**Report: TAB REPORT**  
**Function: Test, Adjust, & Balance**  
**Date: 05/31/2023**

**PROJECT**  
**05-29-23 CULVERS - GRAIN VALLEY, MO**

## **Issue List**

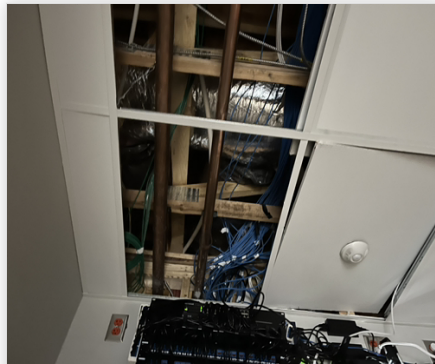
**Issue Name :** 2. RTU-2 Diffuser 2-16 Low on Airflow, Damper Inaccessible  
**Description :** Diffuser 2-16 on the GRD for the electrical room is very low on flow at 175/600 CFM. Suspect the damper is closed at takeoff. Tech is unable to reach takeoff to check for a damper due to ceiling restrictions.  
**Created By :** National TAB                      **Assigned To :** National TAB - Jacob Davidson  
**Status :** Open  
**Originated Date :** 05/23/2023 - Jacob Davidson - National TAB
